SUBJECT: CERTIFIED MINUTES OF THE ACRS SUBCOMMITTEE MEETING ON
EARLY SITE PERMITS (NORTH ANNA), MARCH 2, 2005, ROCKVILLE,
MARYLAND

**ADVISORY COMMITTEE ON REACTOR SAFEGUARDS
EARLY SITE PERMITS SUBCOMMITTEE MEETING MINUTES
MARCH 2, 2005
ROCKVILLE, MARYLAND**

Safety Review of the North Anna Early Site Permit Application

SSE vs RG 1.60

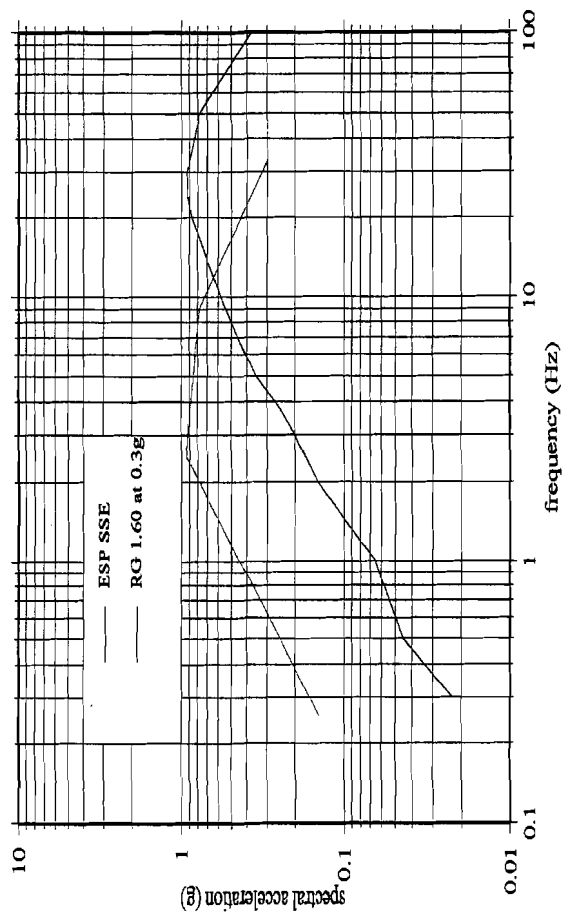
- Because North Anna is a rock site, site SSE exceeds design SSE at high frequencies for designs certified to date
- COL applicant would need to resolve disparity if one exists (dependent on design selected)
- See SSE vs. RG 1.60 diagram
